PLAN-EXPANSION JOINT @ ABUT. #1-(EJ-1)

DATE SUB.	PROJECT	VT. RTE. 12A OVER 3RD BRANCH OF THE WHITE RIVER
DATE APP.	LOCATION	BRAINTREE, VT.
DATE DIST.	ARCHITECT	
	ENGINEER	
	CUSTOMER	MILLER CONST. CO.

DR BY: KJM
 REV BY:
 JOB NO. #2202
 DWG NO. E1

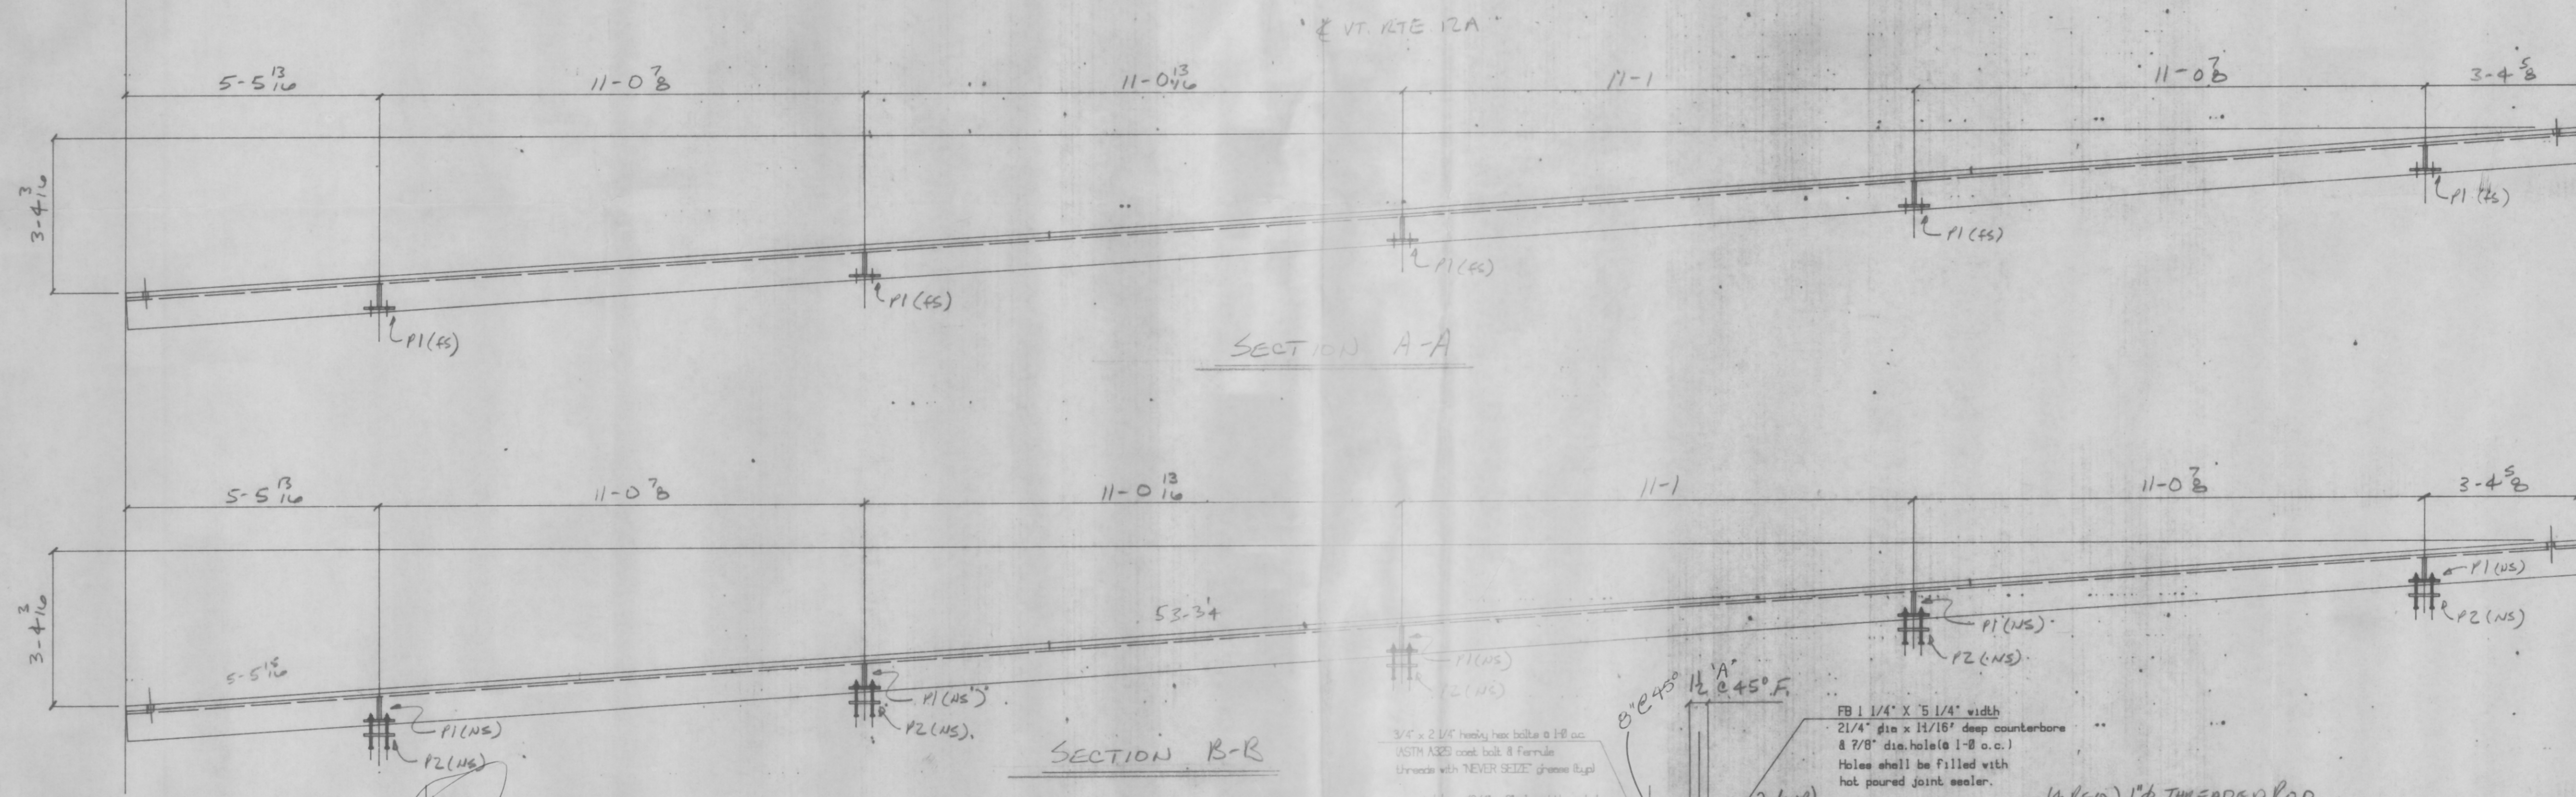
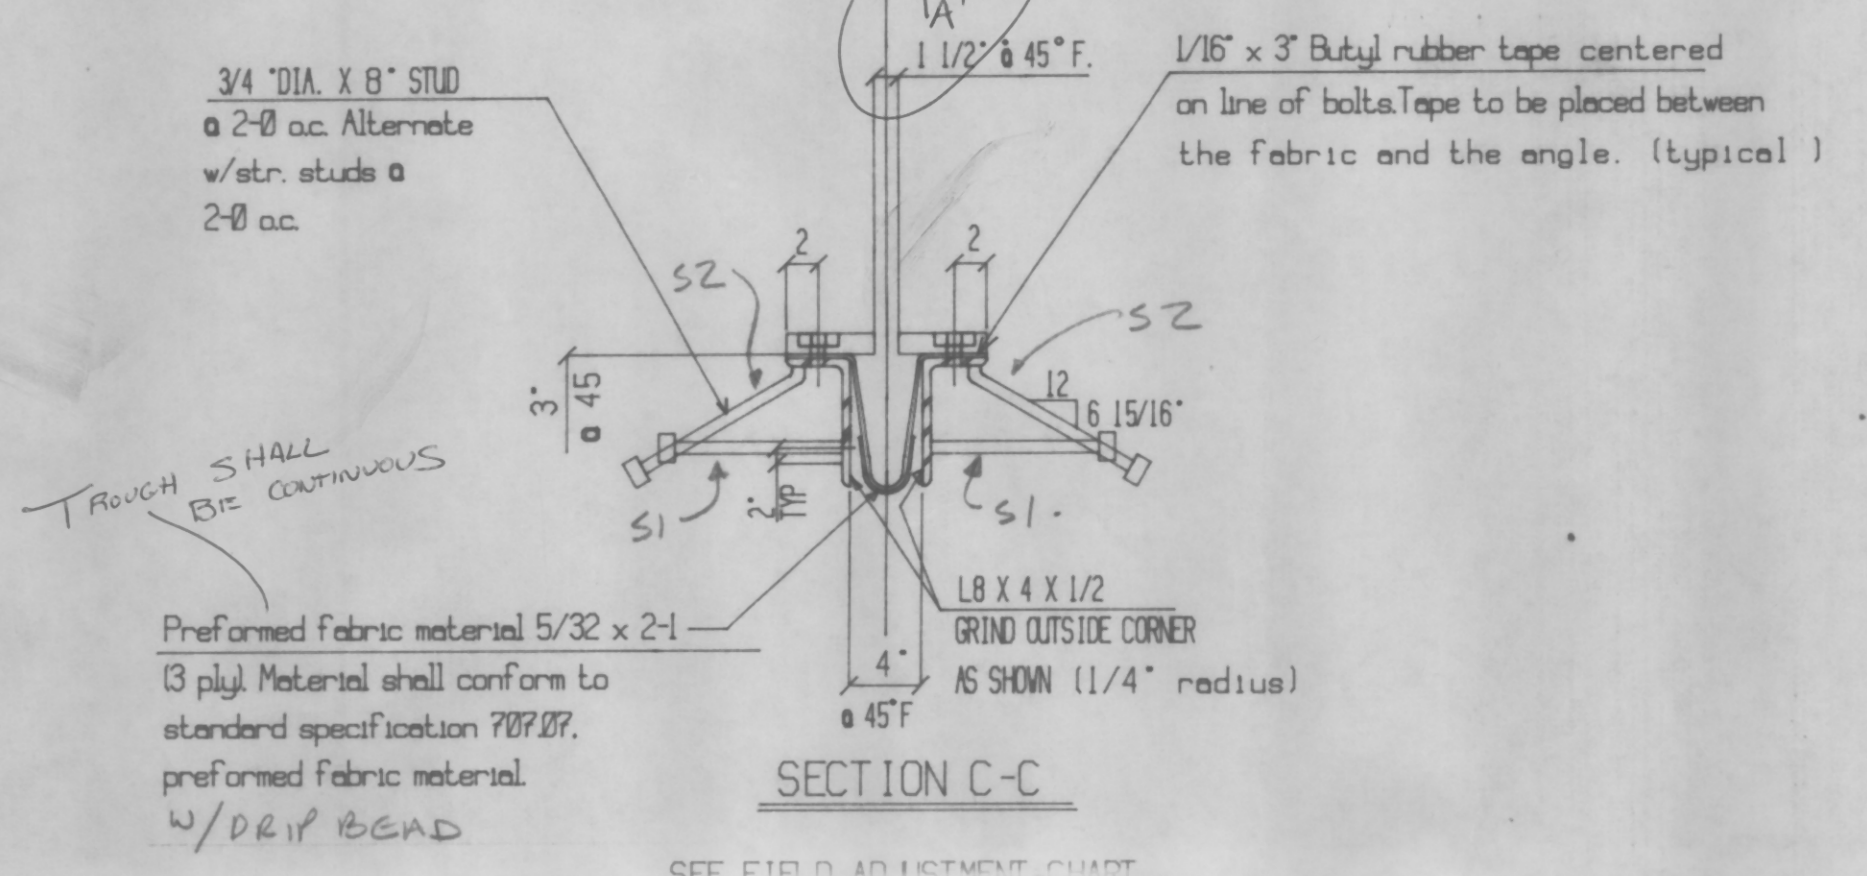
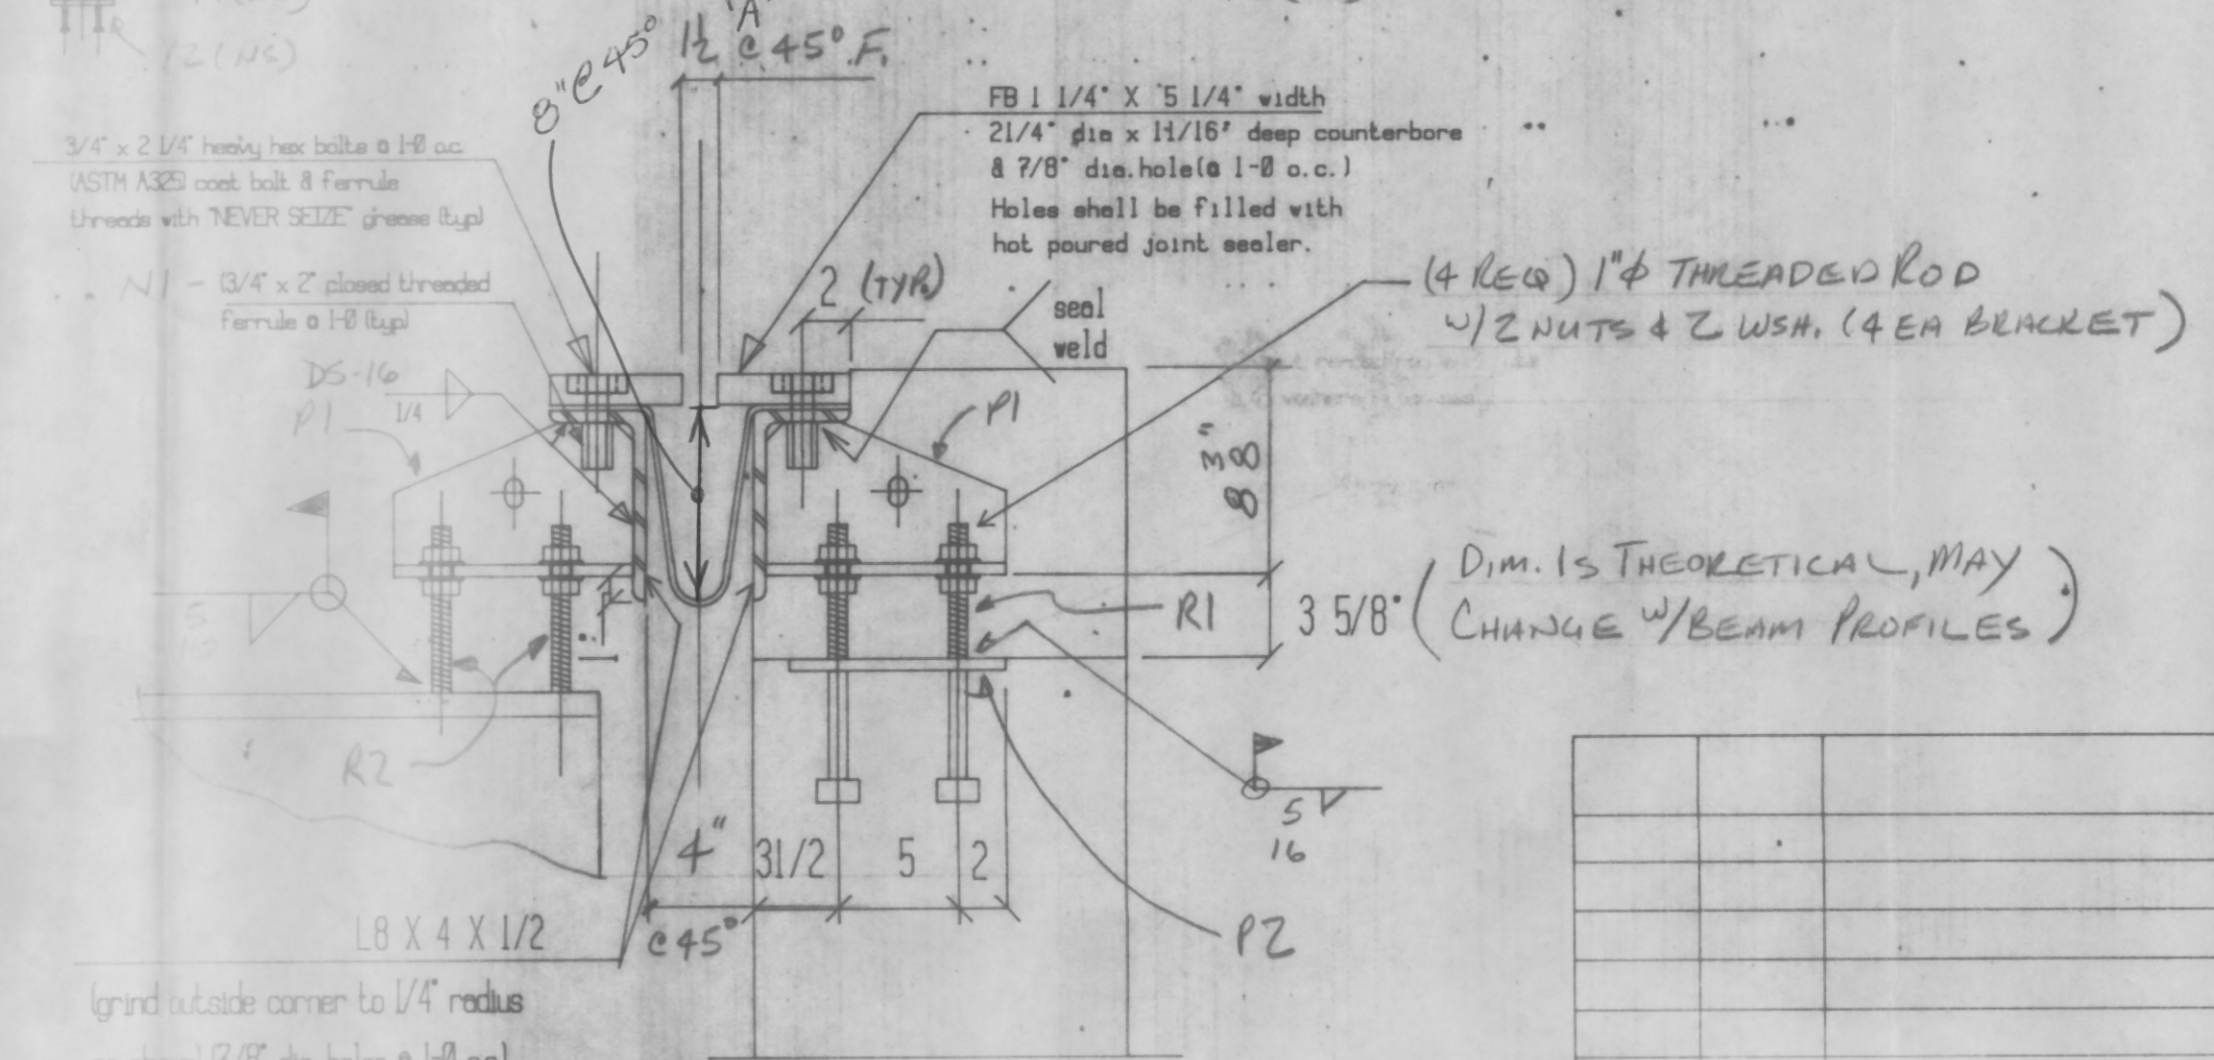
Note: Make sure SPACING OF STUDS ARE ADJUSTED FOR CLEARANCE IN VICINITY OF BRACKETS AND BLOCKOUT FOR DOWNSPOUT.
